## ADDENDUM REPORTS

<b>Application Number:</b>	<b>AWDM/1962/22</b>	<b>Recommendation - Approve subject to a s.106 Agreement, the receipt of additional information and outstanding consultee responses</b>
<b>Site:</b>	<b>Land At Former 5 Brighton Road, Shoreham-By-Sea</b>	
<b>Proposal:</b>	<b>Proposed mixed-use re-development between 3 and 8 storeys comprising 21 townhouses, mixed-use apartment block of 24 flats, commercial unit, riverside walk, play area, landscaping, and parking (with revised design and provision of on-site affordable housing)</b>	
<b>Applicant:</b>	<b>Cayuga 011 LLP</b>	<b>Ward: Southwick Green</b>
<b>Agent:</b>	<b>Lewis and Co Planning SE Ltd</b>	
<b>Case Officer:</b>	<b>Stephen Cantwell</b>

# Amended Parking Plan - 5 Brighton Road (AWDM/1962/22)

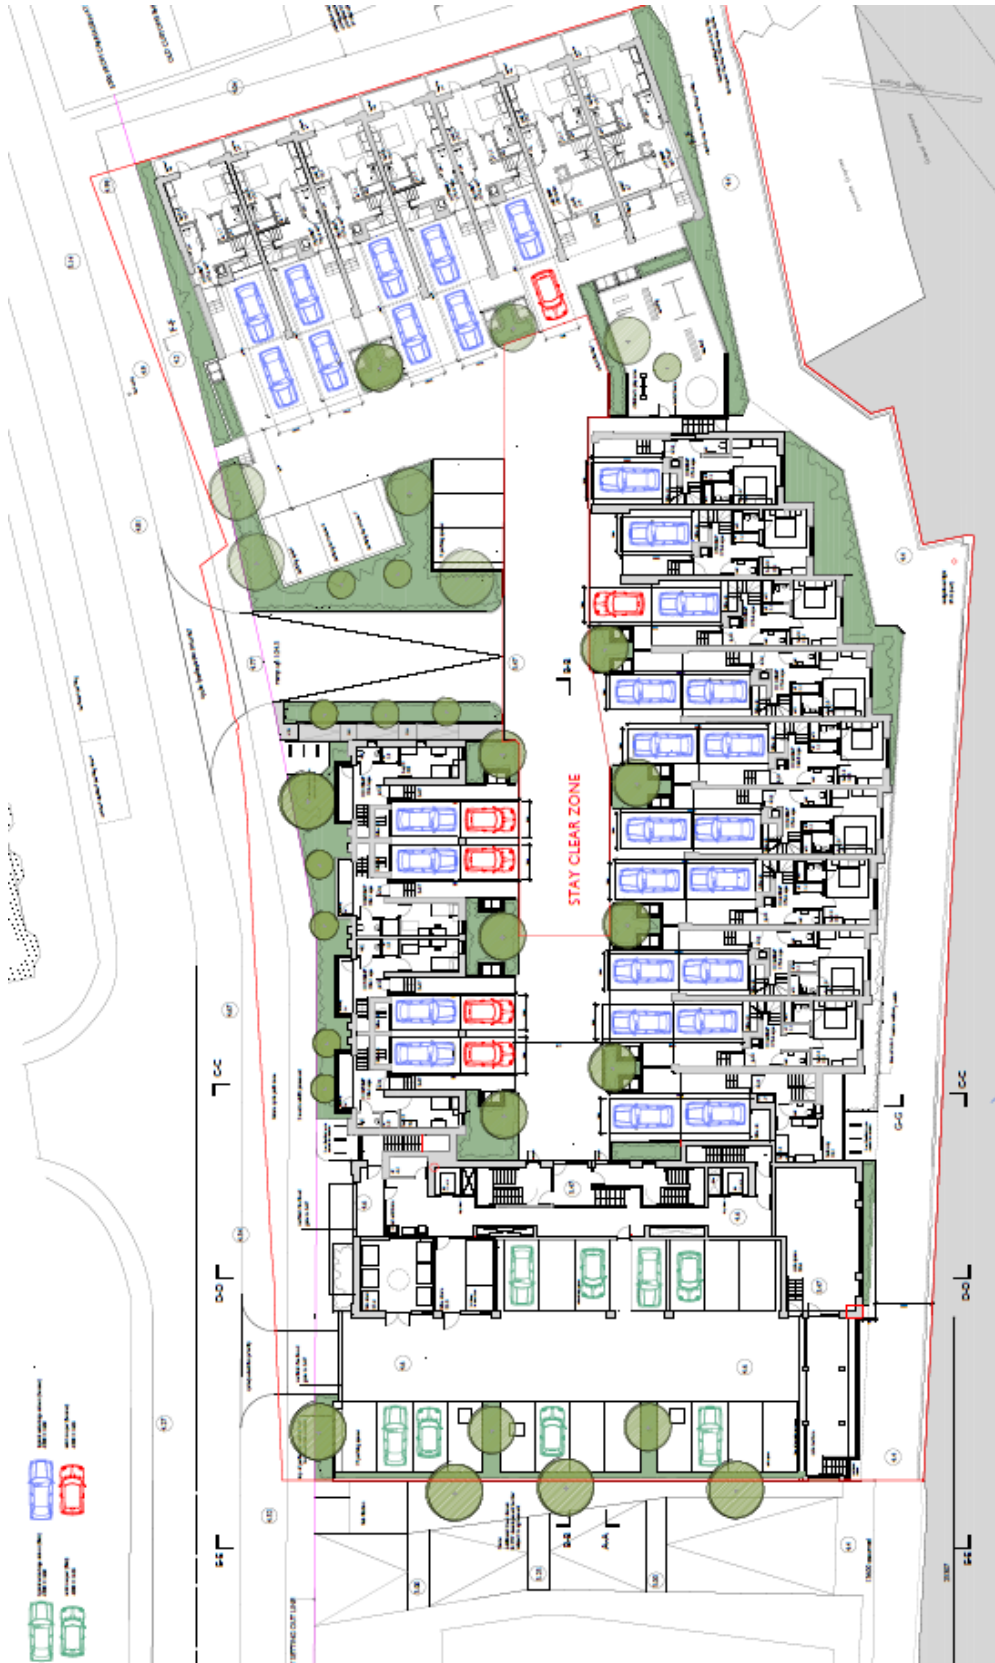
1. Highway Contributions: These remain as at September 2022 [as listed in summary of response in main report]
2. Parking plan: an amended version showing possible further driveway spaces of 2.4 x 4.8m and a clear area for services and emergency vehicles has been received and is acceptable to the Highway Authority.

*[Officer comment: the amended parking plan, which is included at the end of this addendum Item report) shows 10 no additional tandem driveway spaces, which are 2.4 x 4.8m, and 6no. which are slightly below this. If the 10no. were included, this would increase the total to 54no. which is closer to the parking demand for PBZ4 of between 81 and 85 spaces and slightly more than the Census Data would indicate for houses. As pointed out in the Committee report, this would affect the landscape character of the courtyard, but in mitigation, most spaces are not forward of the tree and shrub planters in front of each driveway.*

*In practice, it is unlikely that a planning condition could seek to reasonably and enforceably prevent the parking scenario of additional spaces in this inward-looking courtyard, and so it is likely that the parking as shown would occur. However, it is important that the keep-clear area, which is required for service and emergency vehicles and which is visible from the site entrance, is kept clear at all times (the drawing currently shows two cars here -*

*although these are only included as a key, a revised drawing removing these has been requested). Accordingly it is recommended that draft planning condition 18 be amended as below in italics.*

1. Contributions-correct as of September 2022
2. Roadside kerb - this will be realigned by the Highway Authority.
3. A bus shelter with real time information - will be provided via the financial contribution to be provided towards sustainable transport improvements within the JAAP area.
4. Car Parking- the recent plan reviewed (drawing 1545 PA 046) as requested and no concerns raised to spaces shown with dimensions of 2.4 by 4.8 metres accepted.

*'18. No part of the development shall be occupied until the vehicle parking and manoeuvring spaces, including the keep clear area serving that part (including associated visitor/unallocated parking and car club space) has been constructed and provided in accordance with the approved details. Once provided the spaces shall thereafter be permanently retained at all times for their designated purpose and that the keep permanently clear area is kept clear of vehicles and any obstructions. ]*

- i) **The receipt of amended parking plans *(to remove erroneous key)*;**
- ~~ii) **The receipt of a satisfactory updated Daylight & Sunlight Assessment amended parking plans;**~~
